NRC Request

1. *Entergy Nuclear Operations, Inc. (the licensee) stated in its submittal dated June 30, 2009, that the break selection process was re-performed after fibrous debris zones of influence (ZOI) were reduced. However, the licensee further stated that after a significantly large fiberglass component was identified, deference was given to evaluating breaks for other debris sources. The Nuclear Regulatory Commission (NRC) staff cannot determine from this information whether the break selection was conservative. Please verify and justify that the break selection process identified the break that results in the maximum potential fibrous debris load and that this debris load was considered in the remaining portions of the head loss evaluation.*

Entergy Nuclear Operations Response:

Figure 10.1: Cal-Sil Sample Before Erosion Testing

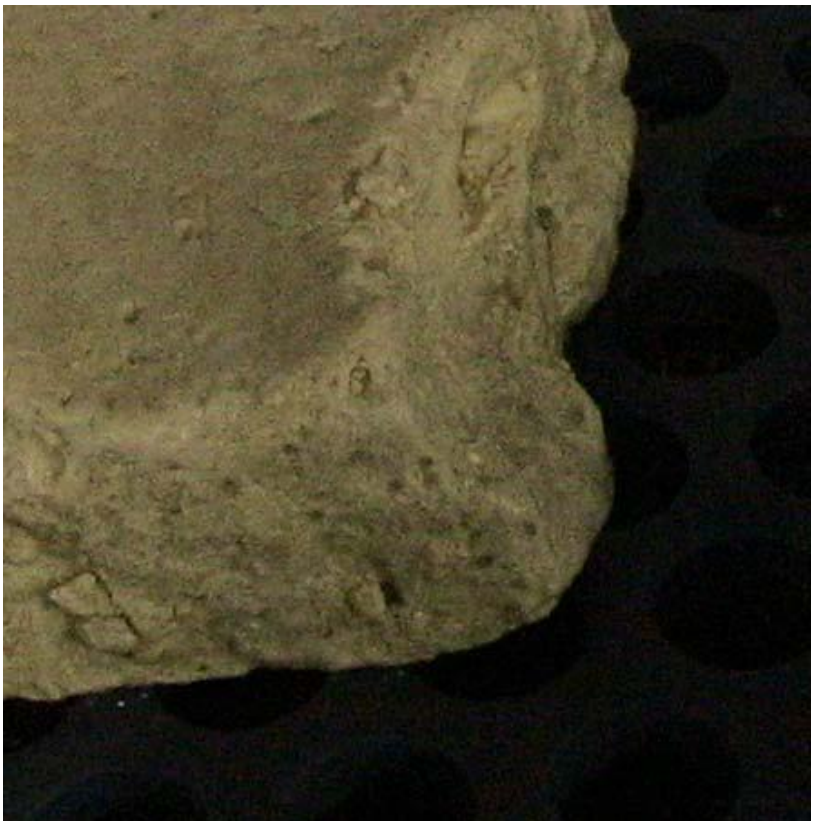
b. *Please provide the basis for concluding that pieces of Marinite debris will not transport to the strainers or erode in the post-LOCA containment pool. Although Section 4.2.2.2.5 of NEI 04-07 states that Marinite can be assumed to be broken into large chunks, the staff could not determine that NEI 04-07 or the accompanying safety evaluation provides a basis for concluding that this Marinite is not susceptible to transport or erosion. The staff has seen results from testing demonstrating that Marinite does erode when submerged and exposed to flow.*

Erosion testing of Marinite showed that when exposed to flow velocity of 0.4 ft/s for 32 hours, the Marinite samples experienced a maximum weight loss of 1.22% [Ref. 10.5]. However, this quantity was determined to be primarily the wearing away of the rough edges initially found on the broken Marinite sample pieces. This erosion pattern was very similar to that observed on Cal-Sil samples tested concurrently with the Marinite. Images of the Cal-Sil before and after erosion testing are shown in Figure 10.1 and Figure 10.2, respectively.

Thus, although there was a 1.22% erosion of sample weight over 32 hours, it is expected by the erosion pattern that this would represent the majority of the erosion of the sample expected to take place over the 30 day mission time.

Figure 14.1 - OPG 5D Test Target Post-Destruction (Jacketing Removed) (Figure D4 in Ref. 5)

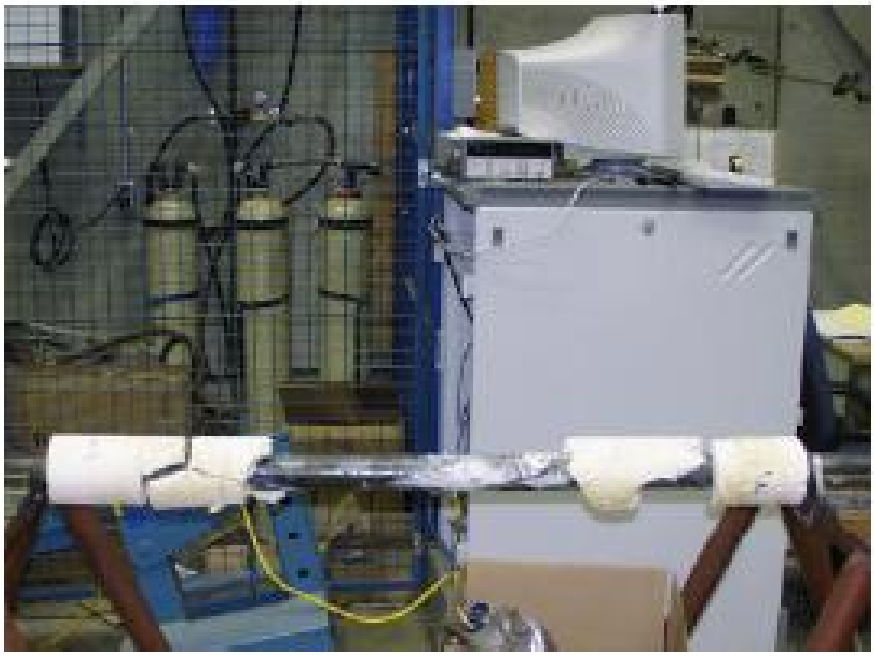
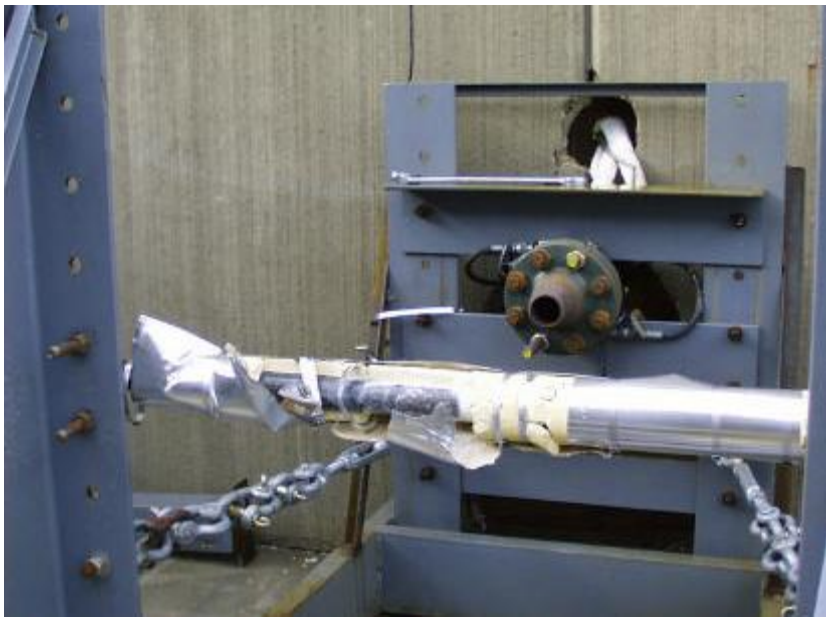
14. *The June 30, 2009, supplemental response appeared to indicate that only 50% of the calcium silicate within a 5.45D ZOI was assumed to be destroyed into small fines. The other 50% of the calcium silicate within this ZOI was assumed to remain intact following the impact of the LOCA jet. The assumed size distribution appeared to be based on OPG testing for which less than 50% of the target calcium silicate was damaged by jet impingement. Please address the following items concerning the assumed calcium silicate debris distribution:*

Based on the photographic evidence from the OPG tests used in determining the size distribution of destroyed Cal-Sil debris (5D, 7D, 9D, 11D, 13D, and 20D tests presented in Figures 14.1 through 14.6) it is apparent that most significant destruction of the target insulation was not directly in front of the jet nozzle but was instead located almost randomly along the length of the target [Ref. 5]. The 9D and 7D tests (OPG tests 8 and 12) show a very uniform destruction pattern along nearly the entire length of the target, with the far side of the target insulation removed and the nearside remaining intact under intact jacketing. The 13D and 20D tests (OPG tests 14 and 15) show a destruction pattern centered at one end of the target, with the centerline of the target directly in front of the nozzle relatively intact.

Figure 3. Immediate area of A-Loop SG compartment [Ref. 15.1]

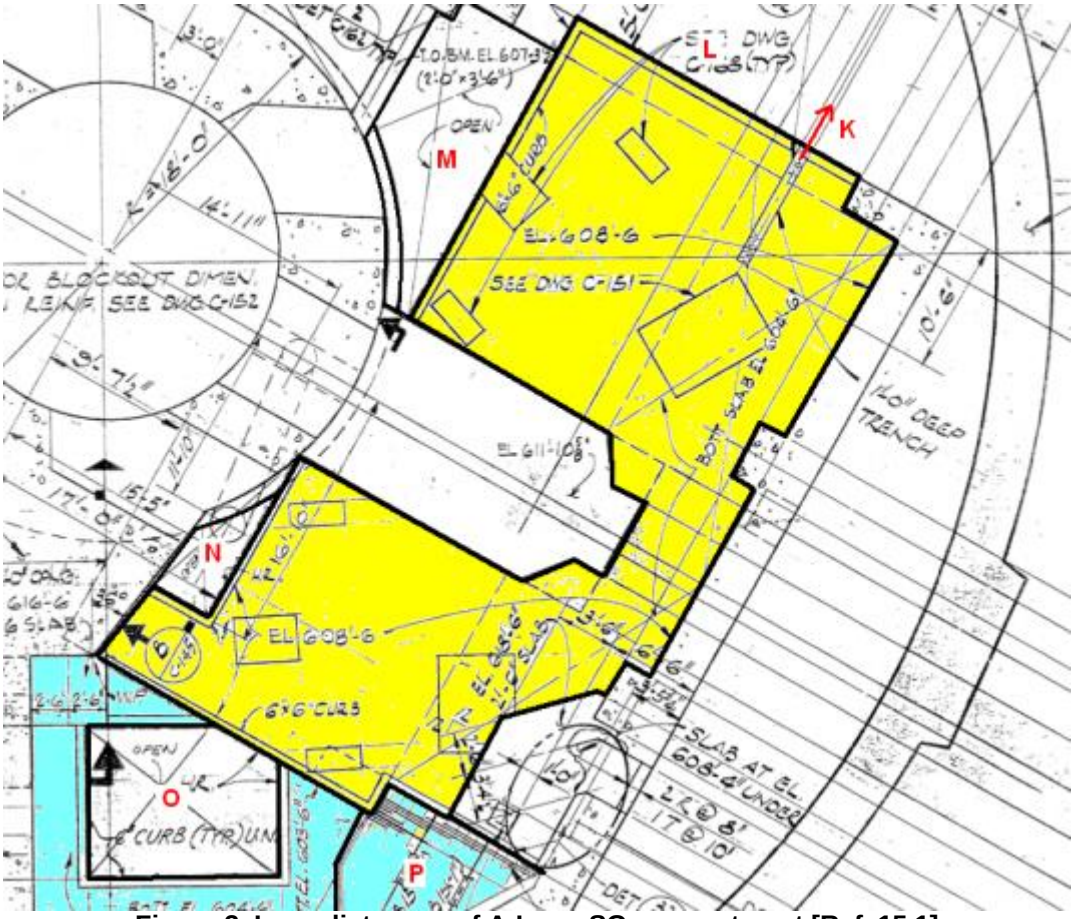
15. *The licensee's June 30, 2009, supplemental response stated that large pieces of debris were assumed to be retained on the 608'6" elevation (EL) rather than transporting to the 590' EL. The licensee's response added that it was ultimately inconsequential whether the large pieces were retained on the 608'6" EL or washed down to the 590' EL, since direct transport to the strainer would not occur in either case, and an equivalent degree of erosion would occur regardless of the elevation on which the debris was assumed to settle. It was not clear to the NRC staff that it was inconsequential whether large pieces remained on the 608'6" EL or transported to and settled on the 590' EL. In particular, the NRC staff expected that the flow conditions (e.g., velocity and turbulence) on these two elevations could be significantly different, thereby leading to different percentages of eroded debris. In particular, the NRC staff expected that erosion would be more severe on the 608'6" EL because (1) shallow pools exist, (2) there is significant potential for break and/or spray drainage to create high-velocity and high-turbulence flow conditions, and (3) the potential exists for direct exposure to break and/or spray drainage flows. It is not clear to the NRC staff that flow conditions of this sort are bounded by industry erosion testing conducted with significant submergence, no direct exposure to drainage flow, and relatively low velocity and turbulence values, and how this potential discrepancy has been addressed in the licensee's strainer performance evaluation. Therefore, please identify the range of water velocity and turbulence levels expected on the 608'6" EL, the expected water depth, as well as the basis for concluding that an equivalent degree of erosion would occur for debris retained on the 608'6" EL as would occur on the 590' EL considering the industry erosion test conditions and results. As applicable, please also provide similar discussion for any other locations where significant debris holdup was credited for which erosion may occur under similar conditions to that applicable to the 608'6" EL (e.g., the stairwells leading from the 608'6" EL to the 590' EL).*

For Palisades containment the limiting break from a debris generation and also a debris transport perspective occurs in the A-loop. The A loop geometry is shown in Figure 3 with run-off paths identified by letter code. Overall, 83 ft of 6" high curbing surround the area marked in yellow. Only one trench-like opening exists in the curbing. This run-off path is marked K. Approximately half of the area is protected from direct spray from above by the steam generator and other concrete closures in the upper elevations of containment. Given the spray and break-flow inputs that exist during an A-loop break, the floor of the area marked in yellow will flood to over-flow the curbing. To support the run-off of water, the water level will rise to 7". Given the length of the curbing, an approach velocity to the curb of 0.09 ft /sec can be calculated. This velocity is insufficient to allow the larges to transport out of the curbed area since the lift-over-curb velocity for larges is 0.34 ft/sec [Ref. 15.2 and 15.3]. While the areas of direct break flow

impact may be subjected to high velocities it is expected that a) the duration of exposure of a large amount of insulation to such high velocities is very short as the insulation is pushed away by sheeting water after the initial blast and blow-down b) the amount of insulation exposed to high velocities for an extended period of time is very small. Even though a large amount of debris will be pushed to areas where break flow no longer provides significant velocity and spray flow does not exist (half of the area is covered by concrete slab or protected by the upper geometry of the steam generator) large debris is eroded to fines at a value of 10%. Furthermore, note that the velocities approaching the curb will drop off dramatically to the point where larges will stop transporting and not block the curbing.

Figure 16.4. View of SG-A compartment near pressurizer

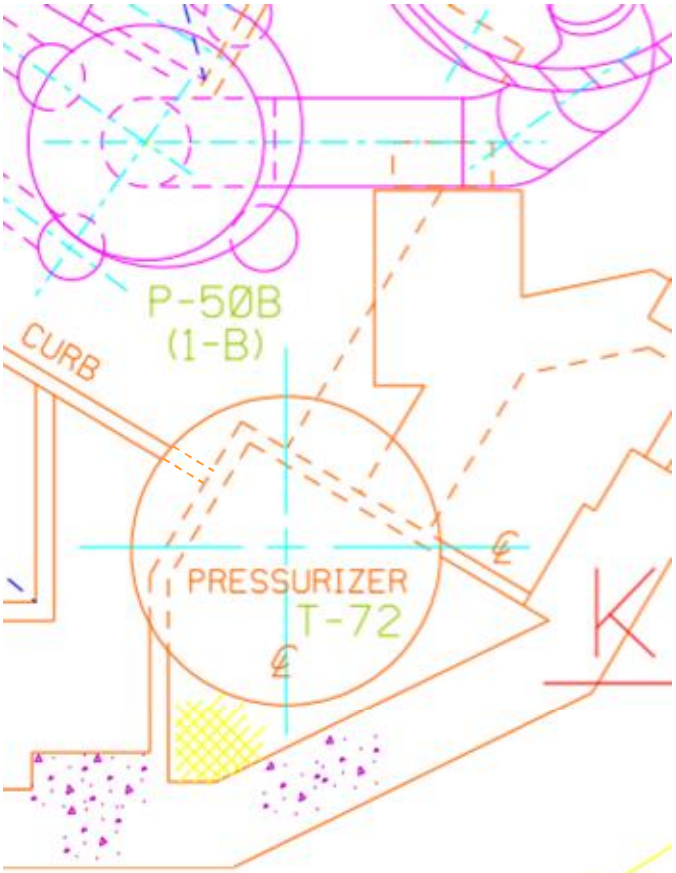
16. *Although the licensee's June 30, 2009, supplemental response quoted a statement in NUREG/CR-2982 indicating that mineral wool can remain afloat for extended periods of time, it did not appear that the licensee had accounted for the potential for floatation adequately in the following two respects:*

- While it is possible that some very small fraction of mineral wool smalls from the pressurizer could end up on the main steam generator floor, this debris will mix with Nukon fiber debris.
- Small mineral wool debris that remains afloat in the main steam generator compartment could flow over the existing curb and down into the containment pool. The test basis was developed by neglecting this possible transport (floating), instead eroding all mineral wool debris, including the vast majority which is not subject to spray flow or other transport mechanisms.

Based on the above discussion debris transport of mineral wool larges by floatation is not credible and only possible for small fractions of mineral wool smalls. Although the bulk of the mineral wool debris will be located on largely dry grating, all mineral wool debris smalls and larges were eroded at 10% to fines leading to a very conservative testing basis for mineral wool debris.

Figure17.1 – Containment Erosion Zones

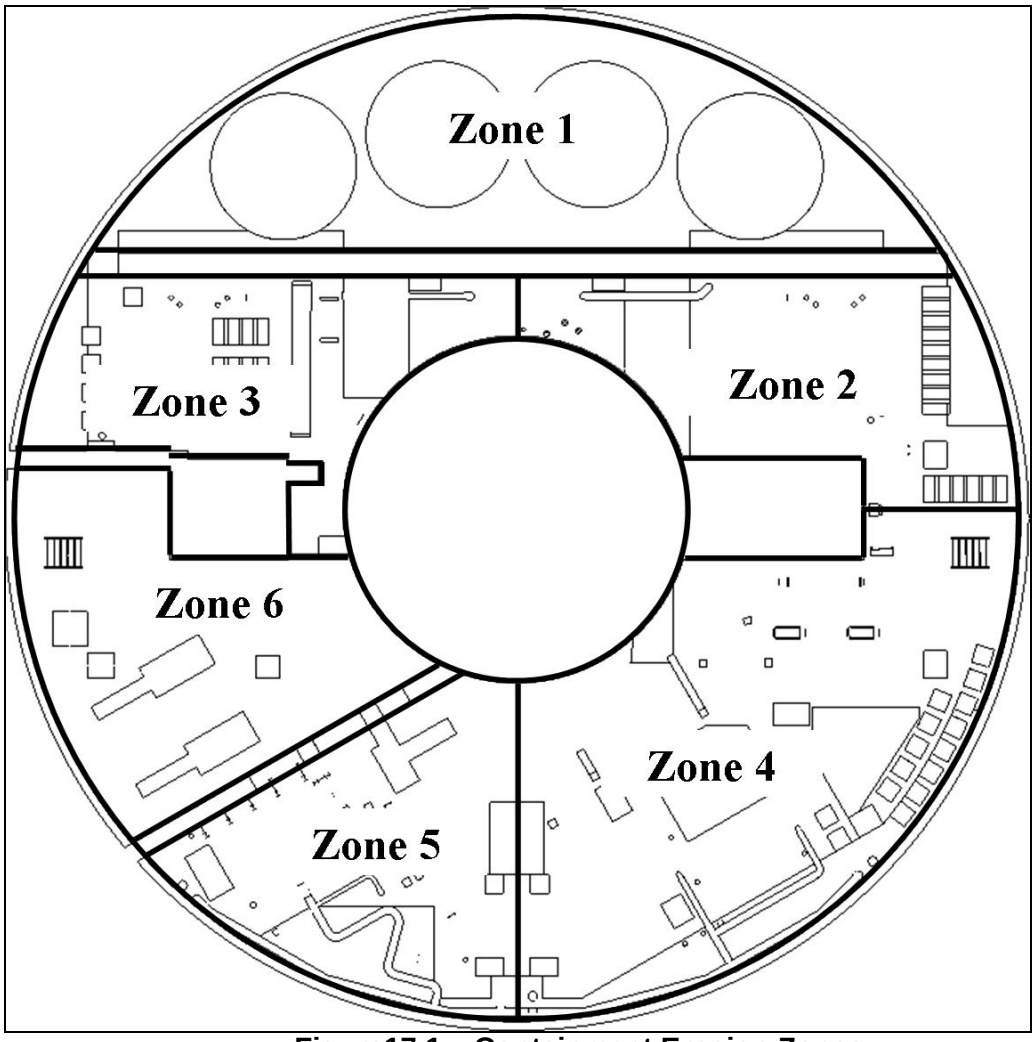
a. *Please describe the test facility used for any erosion testing and demonstrate the similarity of the flow conditions (velocity and turbulence), chemical conditions, and fibrous material present in the erosion tests to the analogous conditions applicable to the plant locations where erosion could occur.*

LDFG – Flow Velocity and Kinetic Energy: After the bulk transport of the debris, a total of 64.2% of the small fiberglass debris generated would be on the containment pool floor where it could be exposed to erosion. The average flow velocity and turbulent kinetic energy (TKE) was calculated in six different zones within the containment [Ref. 14]
